CDM-PDD-FORM

<p align="center">Project design document form for CDM project activities (Version 06.0)</p>	
<p><i>Complete this form in accordance with the Attachment "Instructions for filling out the project design document form for CDM project activities" at the end of this form.</i></p>	
<p align="center">PROJECT DESIGN DOCUMENT (PDD)</p>	
Title of the project activity	Nallakonda wind farm in Andhra Pradesh
Version number of the PDD	<u>04.0</u>
Completion date of the PDD	<u>23/11/2015</u>
Project participant(s)	Tadas Wind Energy <u>Private</u> Limited (previously known as Tadas Wind Energy Limited)
Host Party	India
Sectoral scope and selected methodology(ies), and where applicable, selected standardized baseline(s)	Sectoral scope: 01 Energy industries (renewable / non-renewable sources) Selected Methodology: ACM0002 "Consolidated baseline methodology for grid-connected electricity generation from renewable sources" Version- 13.0.0

Estimated amount of annual average GHG emission reductions	100,630 tCO ₂ e

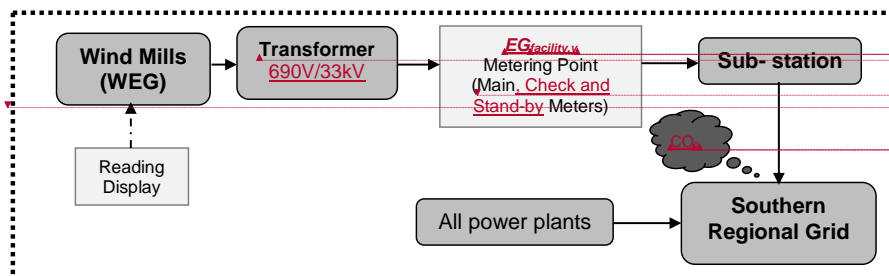
Project Boundary: The diagram in section B.3 of revised CDM-PDD-FORM, v04.0 has been revised in order to reflect the actual metering position and indicate the emission sources and GHGs included in the project boundary along with data and parameters to be monitored; in-line with Instructions for filling out the project design document form for CDM project activities, v06.0.

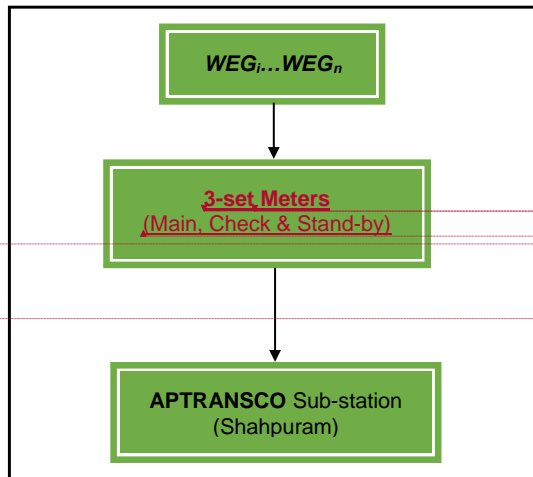
Deleted: The reading will be taken at the individual WEG end by the Enercon operator on site.

Deleted: installed at the substation at a particular date

Deleted: main and the check

Deleted: Yard Meters

Electricity metering systems: The metering system has been corrected in section B.7.1 and B.7.3 of revised CDM-PDD-FORM, v04.0 in-line with the actual practice observed at site. Accordingly, the diagram in section B.7.3 has also been revised in order to reflect the actual metering system.
